Re: Asian RE Hub – Assessment No. 2140

Section 43A Changes to Proposal During Assessment – Asian Renewable Energy Hub

Figure 1 Development envelope and conceptual design at referral

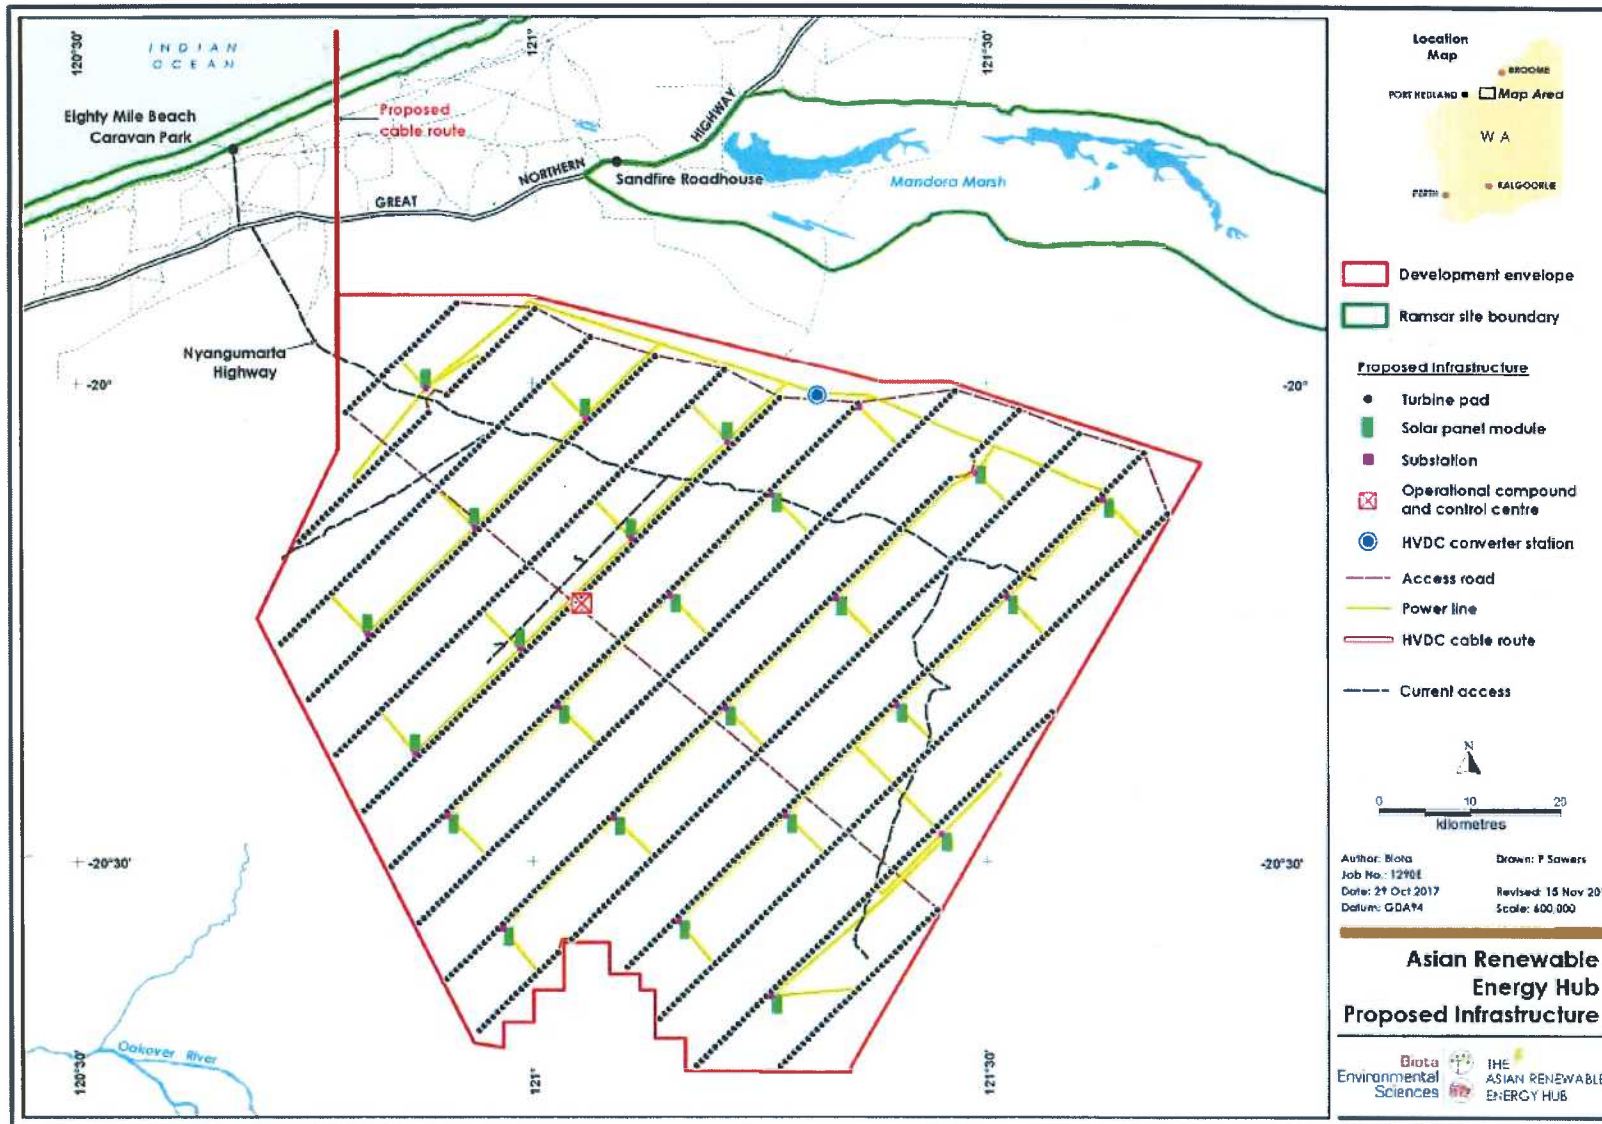
The changes to the proposal conceptual design have been driven by the planned increase in the project's power generation, which is a function of the recent shift in focus of the project to supply renewable power to the Pilbara. This entails an increase in the number of cables exporting power (from two to four), an increase in the number of wind turbines but a decrease in their dimensions, and an increased number of solar panel arrays and associated electrical infrastructure, which has increased the clearing footprint for the project as set out in Table 1 below. Other supporting electrical infrastructure has increased somewhat with the increased renewable power output of the project. Finally, with the refinement of the project design, it has also become clear that the proponent's original intent to co-locate all access tracks was not achievable for engineering reasons and the distribution network would require its own access track. In contrast, it was recognised that some components of the project footprint spatially overlap and were therefore being double-counted in clearing figures (e.g. considering site access track clearing independent of turbine hardstand, when in fact the track footprint will overlay each hardstand). The rationalisation of these refinements, and the overall change to the proposal scope, are reflected in the increased clearing Table 1.

In addition, the proposal has now been refined to a change in temporary disturbance to the seabed of 15.3 ha during offshore transmission cable installation (3 ha at the time of referral), and onshore elements that previously required permanent clearing, will now be temporary only and immediately rehabilitated (burial of the last section of transmission cable corridor near the coast, and temporary construction laydown areas; totalling 613 ha).

We have grouped these marine factors in providing this supporting information, as the change to the proposal is very similar for all three. The only change that affects the marine environment is changing from two export cables to four. While this represents a change to the elements of the proposal, we do not consider it to represent a significant increase in impacts as:
